4 ELLERDALE CLOSE, NW6

DRAWING NAME:
PROPOSED SECOND FLOOR PLAN

PROJECT NO: DRAWING NO: REVISION: SCALE @ SIZE:
P1011 PL603 A 1:100 @ A3
START DATE: FIRST AUTHOR:
JAN 2022 MS

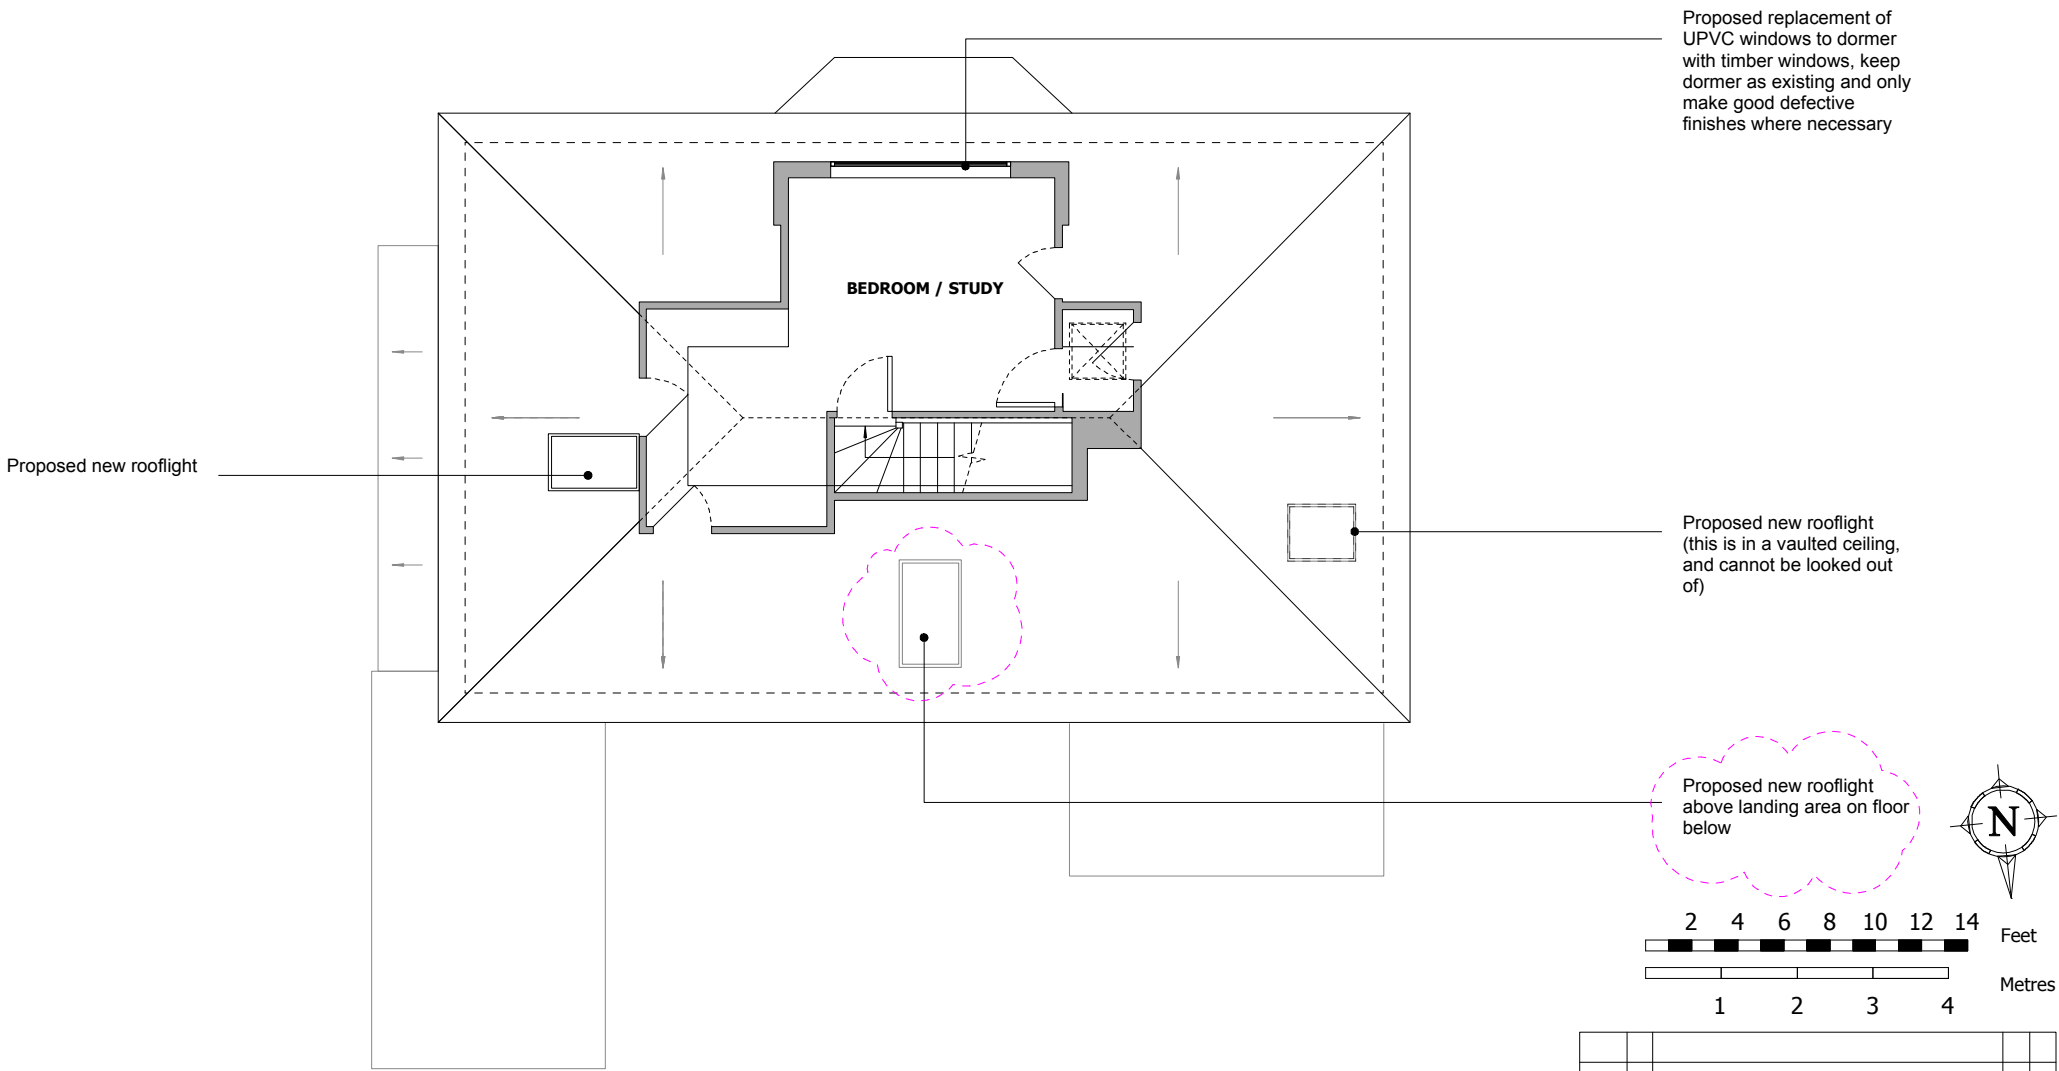
20.04.22	A	Removal of one rooflight from front elevation as requested by planning officer.	MS	GT	
	-	First issue	MS	GT	
DATE:	REVISION:	REVISION COMMENTS:	AUTHOR:	CHECKED:
